## DEPARTMENT OF NATURAL RESOURCES

RE: Response to Modine's May 4, 2005, Response to Comprehensive Groundwater Monitoring Evaluation Report (CME), Modine Manufacturing Company (Modine) Camdenton, Missouri

Concentration vs. Time  
MW-9

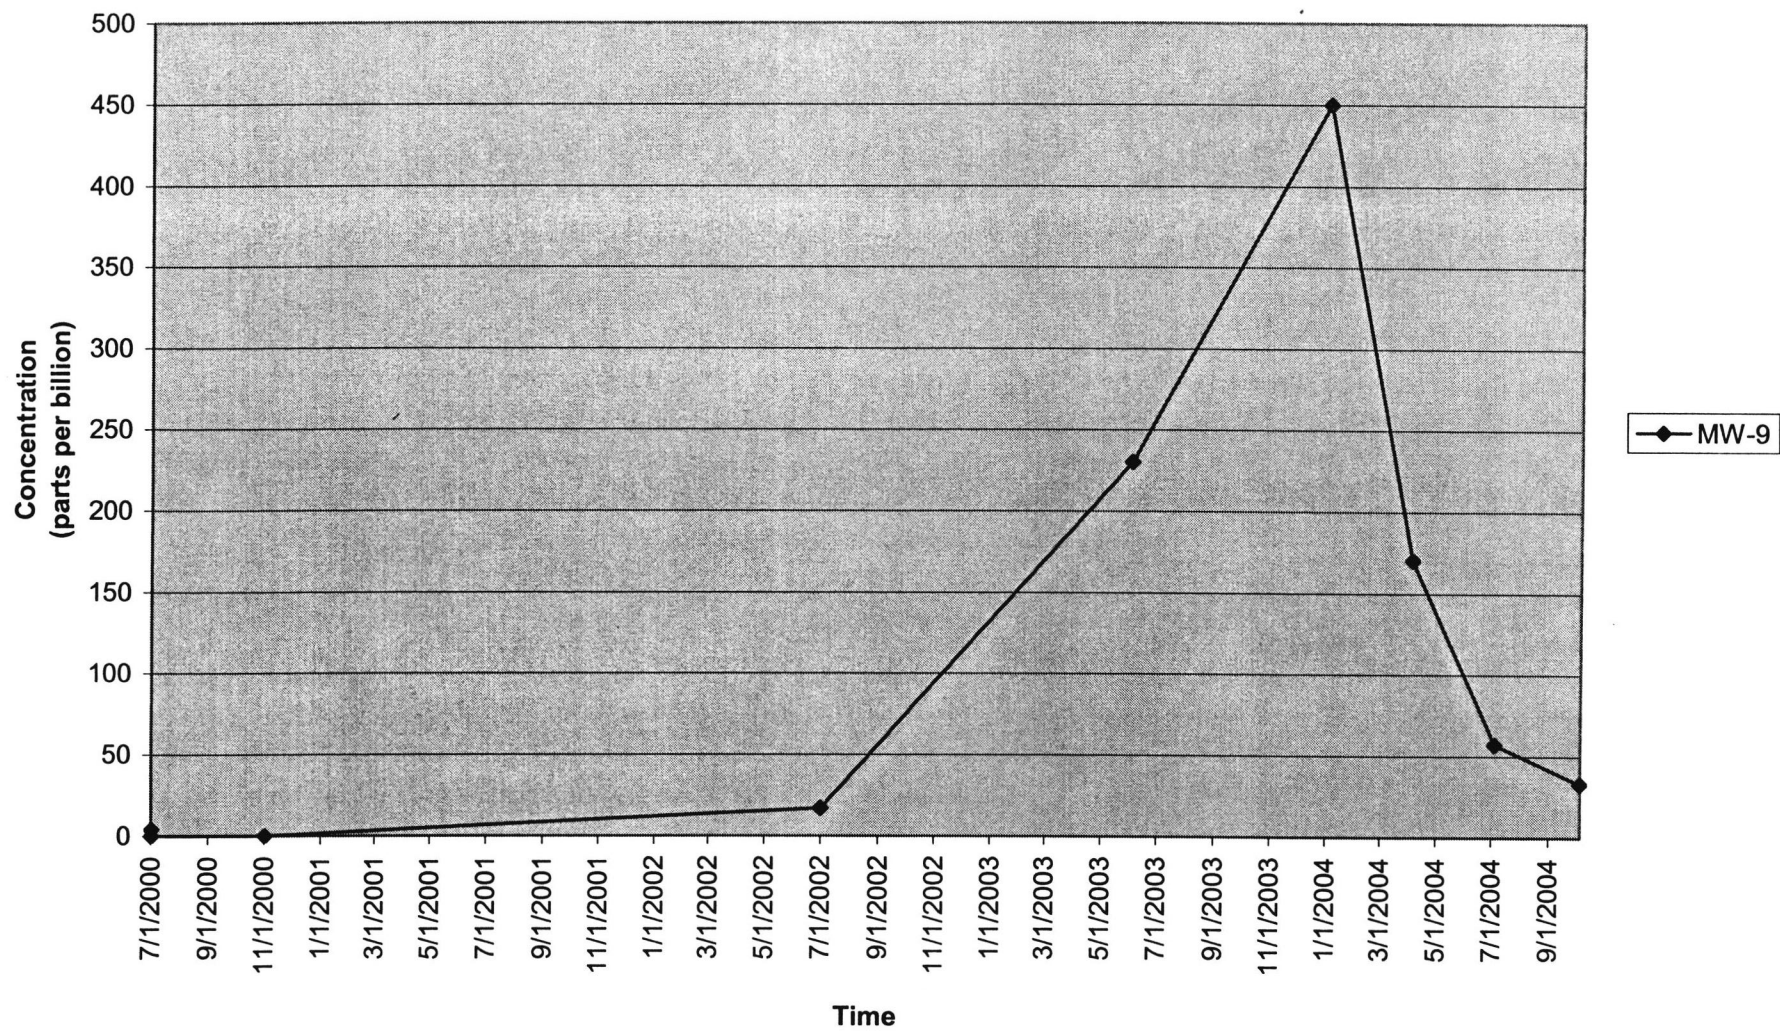
**DNR's Comment:** Modine asserts that a "perched" zone monitoring well south of the facility is not necessary, citing that concentrations in MW-9 have decreased over the past three quarterly monitoring events. Review of analytical results for MW-9, since its installation in June 2000, show that TCE concentrations were non-detect during both the Phase I and Phase II pre- and post-aquifer pumping test sampling events. TCE was not detected in MW-9 until July 2002 at 17 ppb. TCE reached a peak concentration of 450 ppb in January 2004 before declining to 33 ppb in October 2004. Concentrations in MW-13 follow a similar trend, spiking at 290 ppb in January 2004. A concentration vs. time graph for MW-9 and MW-13 are included in the enclosures to this letter. While concentrations appear to be decreasing, the sharp peak in concentrations indicates that the TCE plume in the "perched" zone aquifer is mobile. Although the ravine south of the facility may limit the horizontal extent of the "perched zone," the vertical extent of contamination is not limited by the ravine. TCE in the "perched" zone can be carried to the "deep" zone through secondary porosity such as fractures, bedding planes, and dissolution cavities. In addition, the cone of depression of the Mulberry Well could accelerate TCE migration through secondary porosity features. Installation of a "perched zone" monitoring well nested with a "deep zone" monitoring well immediately south of Modine (replacing abandoned monitoring well MW-3) would help to determine the extent of the plume south of the facility.

As stated above, DNR is willing to defer the installation of a perched monitoring well to replace MW-3 immediately south of Modine until after the RD/RA process is conducted as part of the Superfund investigation. If evaluation of monitoring wells during the RD/RA process do not satisfy DNR's concerns as stated in the CME, then Modine will be required to install the requested monitoring wells.

Concentration vs. Time  
MW-12

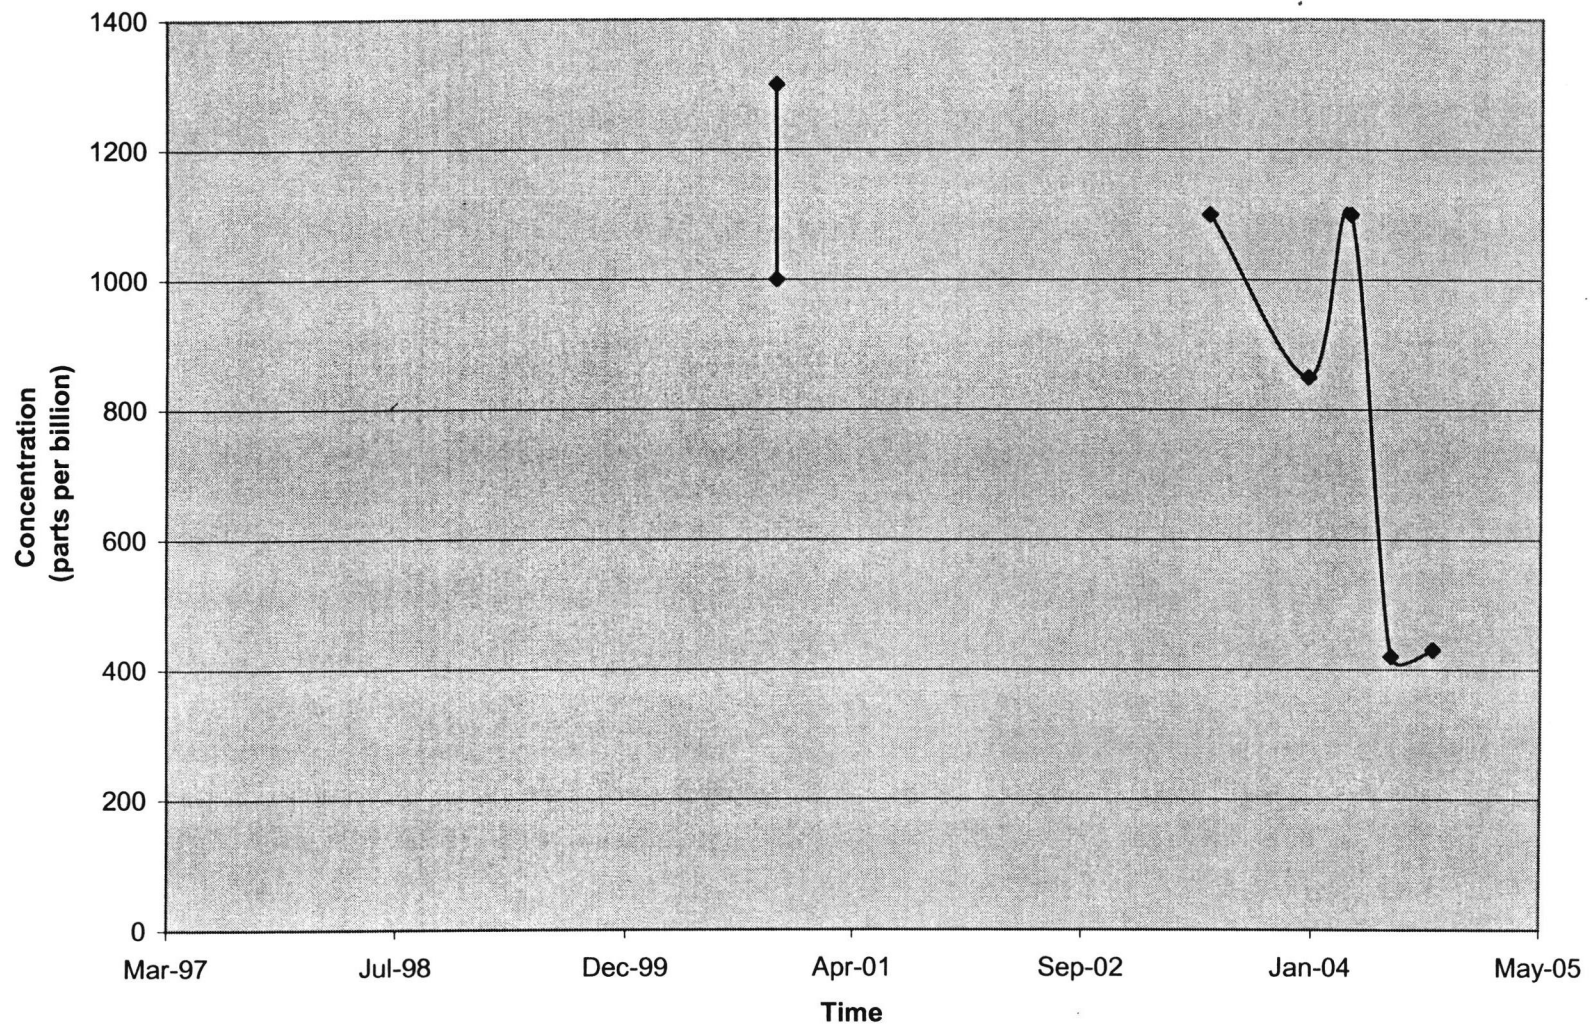
**DNR's Comment:** Increasing concentrations of TCE in both the "perched" zone and "deep" zone monitoring wells indicates a source of contamination remains in the soil and the contaminant plume is mobile. This is evidenced by the pervasive TCE concentrations in "perched" zone monitoring wells MW-12 and MW-8 immediately east of the former sewer line, a spike in concentrations in monitoring wells MW-9 and MW-13, and increasing TCE concentrations in the Mulberry Well. Modine asserts that samples taken from the soil surrounding the on-site wastewater line demonstrate that residual VOC concentrations would not be a continuing source to groundwater contamination beneath the site. The structural integrity of the sewer line from Modine to the lagoon may be inconsistent along the length. Therefore, releases from the sewer line on Modine's property are not necessarily comparable to releases throughout the length of the pipe to the lagoon. Further, depending upon where domestic sewage entered the sewer line, any leakage of Modine's discharges to the sewer may or may not have been diluted with domestic sewage. Differences in soil properties such as density, porosity, and pore throat size would also affect the rate and extent of contaminant releases.
